## MANUFACTURERS' RECEIVER TROUBLE CURES

### **VOLUME 5**

**MANUFACTURERS'  
RECEIVER  
TROUBLE CURES**

VOLUME 5

Fig. 1 — Sparton

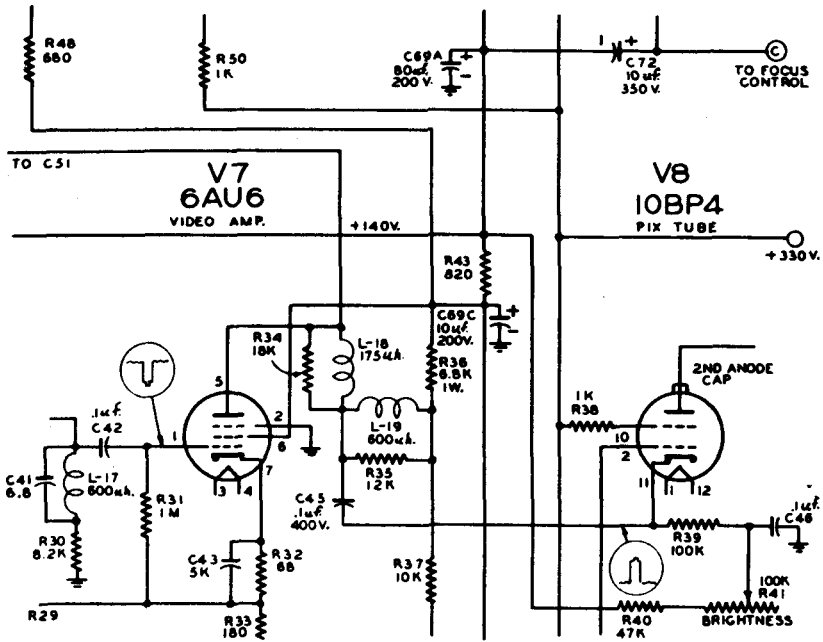
### Reducing hum in final audio stage (see Fig. 1).

To reduce objectionable hum introduced in the final audio stage through common coupling with the video amplifier, sync separator, and sync amplifier, a decoupling network has been devised in the +140 volt line feeding these points. A sectional schematic diagram of the video i-f circuit, showing *V7*, 6AU6 video amplifier, and its associated

R48. When this change is made, the 4-point terminal strip on the receiver chassis should be replaced with a 5-point strip to provide the additional tie point needed. C69C, the 10- $\mu$ f, 200-v capacitor, is an additional section in the original C69A and C69B filter.

1. Disconnect and remove the 4-point terminal strip already in the set.

2. Add the new 5-point terminal strip, part No. PB40200-36.

3. Add R43 (820 ohms,  $\frac{1}{2}$  w), part No. BR12S-821.

4. Disconnect and remove the old C69 filter (two section).

5. Add a new C69 filter (three section), part No. PA4307-15.

Fig. 4 — Stewart-Warner

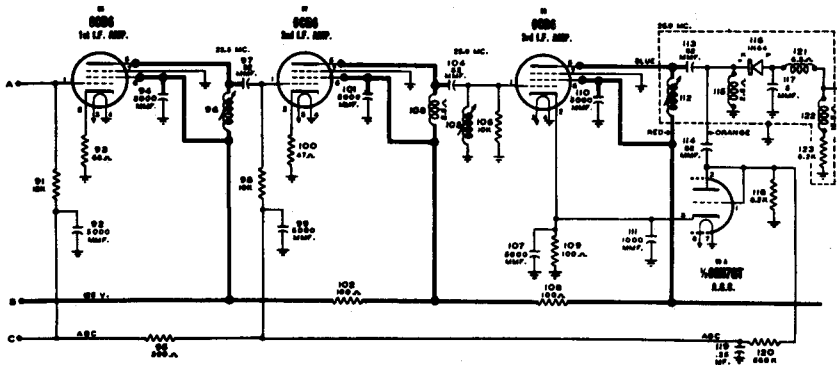
It is possible to improve sensitivity and sync stability on the above receivers by incorporating the changes listed below. Model 9202 receivers coded "Series E" and model 9203 receivers coded "Series C" already contain this modification. The circuit diagram of Fig. 4 includes these changes:

1. Replace all 6AU6 i-f amplifier tubes with 6CB6 tubes.

2. Connect socket pin 7 to ground for each of the three i-f tubes. (This is the suppressor pin on the 6CB6 tube.)

3. Remove 2.2- $\mu\text{f}$  capacitor *C239* from grid circuit of 1st i-f stage.

4. Change 1st i-f grid resistor *R91* from 8,200 ohms to 12,000 ohms.

5. Change 1st i-f cathode resistor *R93* from 47 ohms to 68 ohms; connect it from pin 2 to ground.

6. Change 2nd i-f grid resistor *R98* from 8,200 ohms to 10,000 ohms.

7. Change 2nd i-f cathode resistor *R100* from 82 ohms to 47 ohms. Connect it from pin 2 to ground.

8. Change 3rd i-f grid resistor *R106* from 12,000 ohms to 10,000 ohms.

9. Change agc load resistor *R118* from 47,000 ohms to 8,200 ohms.

Fig. 15 — Sylvania

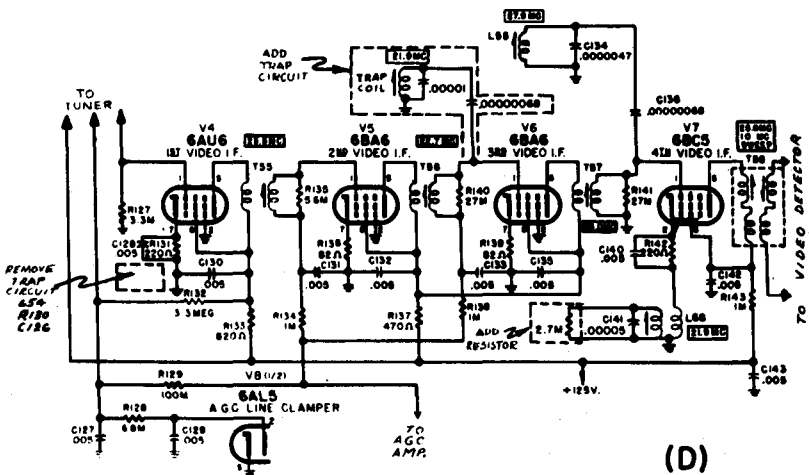
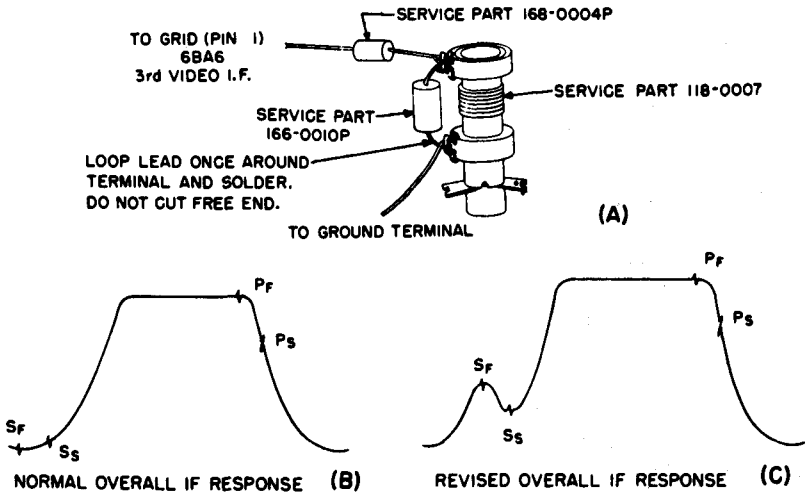
**Improvement in fringe area sound reception (see Fig. 15).**

If it is desired to modify any of the above chassis to improve sound

reception in fringe areas, the following procedure is recommended:

1. Necessary new parts:  
Coil i-f trap, part No. 118-0007.  
Capacitor, ceramic, 10  $\mu\mu\text{f}$  at 500 volts, part No. 166-0010P.  
Capacitor, ceramic, 68  $\mu\mu\text{f}$  at 500 volts, part No. 168-0004P.  
Resistor, 2,700 ohms,  $\frac{1}{2}$  watt, .68  $\mu\mu\text{f}$ , part No. 181-0272.  
(Note: Use 3,900-ohm resistor for chassis 1-387.)
2. Make up an assembly as noted in part (A) of the figure.
3. Remove the following items from the circuit:  
*L54*, trap in 1st i-f cathode circuit.  
*R130*, 33,000 ohms,  $\frac{1}{2}$  watt (same location).  
*C126*, 50  $\mu\mu\text{f}$ , ceramic capacitor (same location).

6. Add 2,700-ohm,  $\frac{1}{2}$ -watt resistor across the secondary of *L68*, 4th video i-f trap coil in parallel with

8. Realign the sound system in accordance with service notes for chassis concerned. The adjustment of the two cores in the sound discriminator secondary *T53* is critical and must be adjusted very carefully for correct alignment.

Fig. 19 — Sylvania

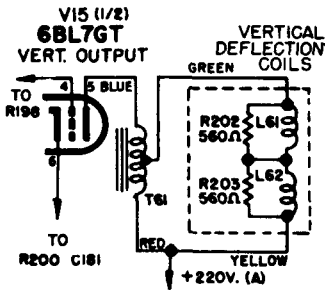
**Improved focus (see Fig. 19).**

To improve focus, the plate voltage connection of the vertical output section of *V15* is modified as shown in the figure. This change is already made in later production.

Fig. 20 — Sylvania

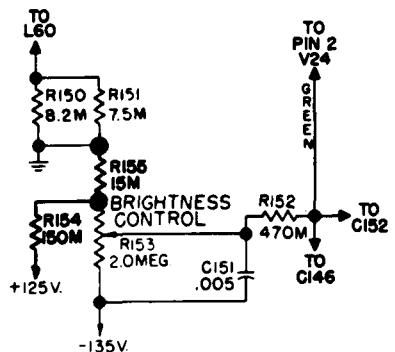
**SYLVANIA** Chassis 1-387-1, -437-3, -502-3  
**Improving operation of brightness control**  
*(see Fig. 20).*

To improve operation of the brightness control, two new resistors are added in later production. These are identified as *R154* and *R155* with values of 150,000 and 15,000 ohms respectively. See figure for connection. In some chassis, these resistors are identified as *R155* and *R156* or as *R156* and *R157*.

Fig. 22 — Sylvania

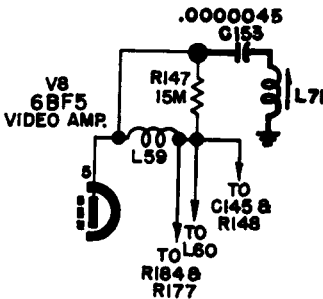
**SYLVANIA** Chassis 1-437-3  
**Reducing 4.5-mc sound interference in picture (see Fig. 22).**

To reduce 4.5-mc sound interference in picture, add *C153*, 4.7- $\mu$ f capacitor, and *L71*, 4.5-mc trap coil, in series between the plate of *V8*, 68F5 video amplifier, and ground. The alignment procedure for *L71* is as follows:

1. Ground the grid (pin 1) of *V6*, the 6CB6 4th video i-f amplifier to chassis.

6. Unground grid of 4th video i-f amplifier and remove test equipment from circuit.

Fig. 23 — Sylvania

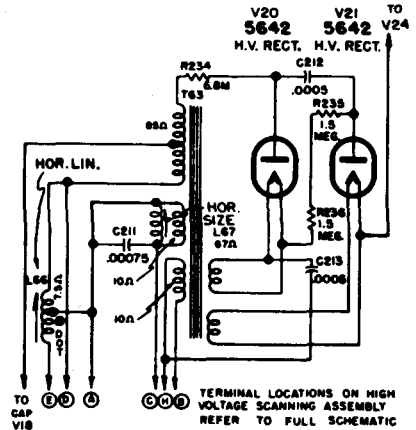
**SYLVANIA** Chassis 1-502  
**Increasing stability of h-v output (see Fig. 23).**

To increase the stability of the high-voltage output, the connection of *C213*, .0005- $\mu$ f, 10,000-volt capacitor, is changed as shown in the

figure. This modification is already included in chassis coded CO2.

Fig. 25 — Sylvania

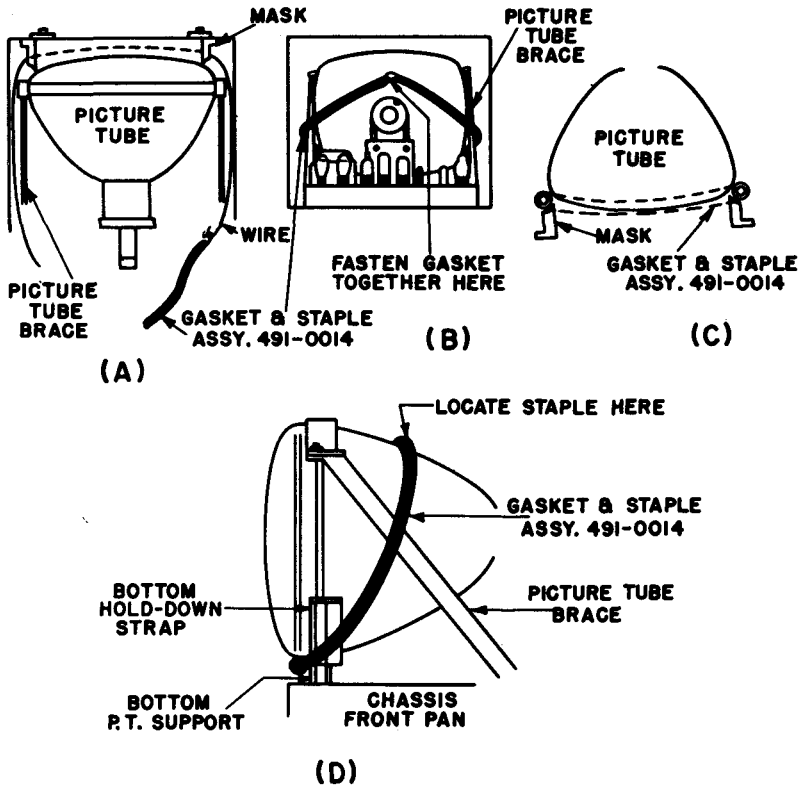
**SYLVANIA** All 17-inch chassis **Installation of dust seals for picture tube (see Fig. 25).**

Mask and gasket assembly, part No. 491-0014, may be installed on 17-inch tv models with the chassis either in or out of the cabinet. The methods for each type of installation are given as follows:

Fig. 26 — Sylvania

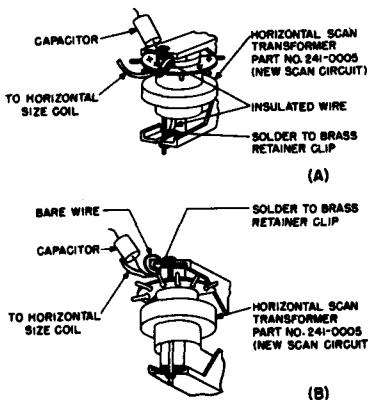
**SYLVANIA** All chassis with h-v transformer 241-0005  
**Arcing and corona in h-v transformer retaining clip**  
**(see Fig. 26).**

Arcing and corona in h-v transformer retaining clip may be corrected by connecting an insulated wire from the clip to the center transformer terminal as shown in sketch (A).

Fig. 27 — Sylvania

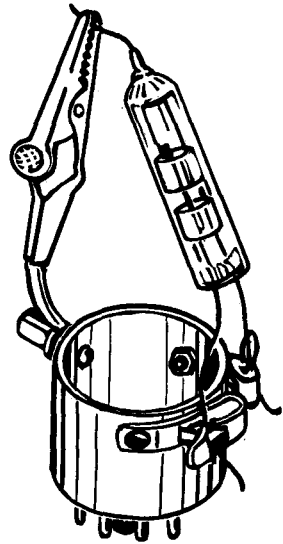
**Testing 5642 h-v rectifier tubes (see Fig. 27).**

The 5642 is designed to be soldered in place and therefore is difficult to test without danger of accidental shorts. One way to test these tubes is to make an adapter as shown. Bolt two Fahnestock clips on an octal tube base and connect to the proper pins as required for the particular tube tester used. Bolt a lead with an alligator clip fastened to it to the other side of the base.

This lead does not connect to the base pins, but solder a tube top cap to the bolt so connection may be made with the tester's regular top cap connection, if required.

Fig. 28 — Trav-ler TV

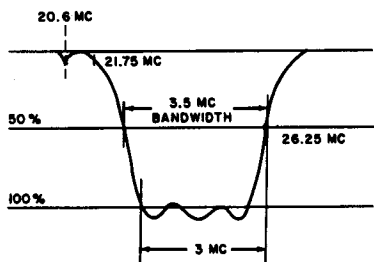
**TRAV-LER TV** Chassis 36A2  
**Improving tracking in fringe areas (see Fig. 28).**

To improve tracking of picture and sound in fringe areas, later production television receivers using the above chassis have incorporated a new i-f coil TV-L-142 in the second and third i-f stages. These are L42B and L42C respectively.

The new coil is approximately 2 inches in length and mounts in the original i-f coil chassis hole. There are two separate windings on each coil form. The winding nearer the chassis is the i-f winding and contains the same number of turns as the TV-L-13 previously used. Mutually coupled and approximately 3/16-inch from the edge of the i-f winding is the audio trap winding with a 47- $\mu\mu\text{f}$  ceramic capacitor in parallel. Both windings have separate tuning slugs and are adjusted individually.

Fig. 34 — Westinghouse

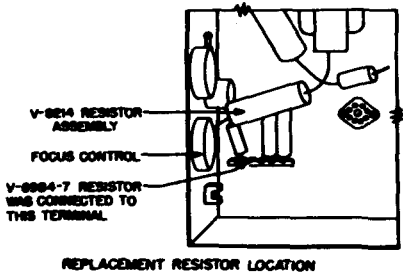
The physical appearance of R463 (110 ohms, 3 watts), which is connected in series with the focus control, is different in later production chassis. The new resistor is covered with asbestos, and the assembly of resistor and asbestos is designated part No. V-8214. The electrical ratings of the old and new resistors are identical.

Only the new resistor, V-8214, is stocked for replacement purposes. Since this resistor must not be bent, the physical location of R463 must be changed if a new resistor is used to replace the old V-6984-7 resistor. The correct location for the new resistor is shown in the figure. The

red wire that runs from the tie point for the old resistor to the tie point for the new resistor should be clipped from the circuit when the new resistor is installed.

Fig. 39 — Westinghouse

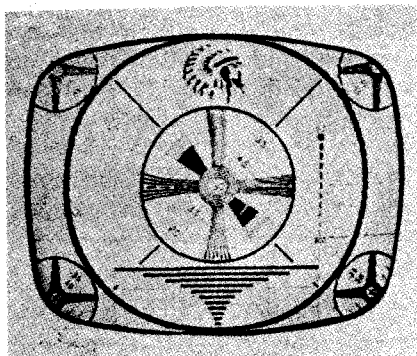
**WESTINGHOUSE** Models with 6AU5 horizontal output tube  
**Ragged picture tube pattern**  
 (see Fig. 39).

Fig. 46 — Zenith

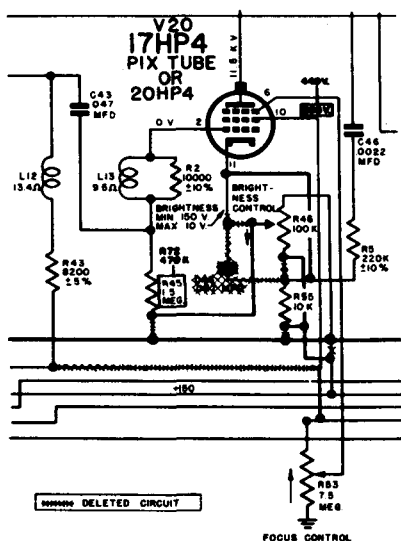
The figure shows a revised brightness control circuit with original components and voltages shown inside boxes. Circuit changes were made to accommodate picture tubes with widely varying focus characteristics. The revised circuit can be used to advantage in those receivers where focusing difficulties are experienced with replacement picture tubes of makes other than those originally supplied in the receiver.
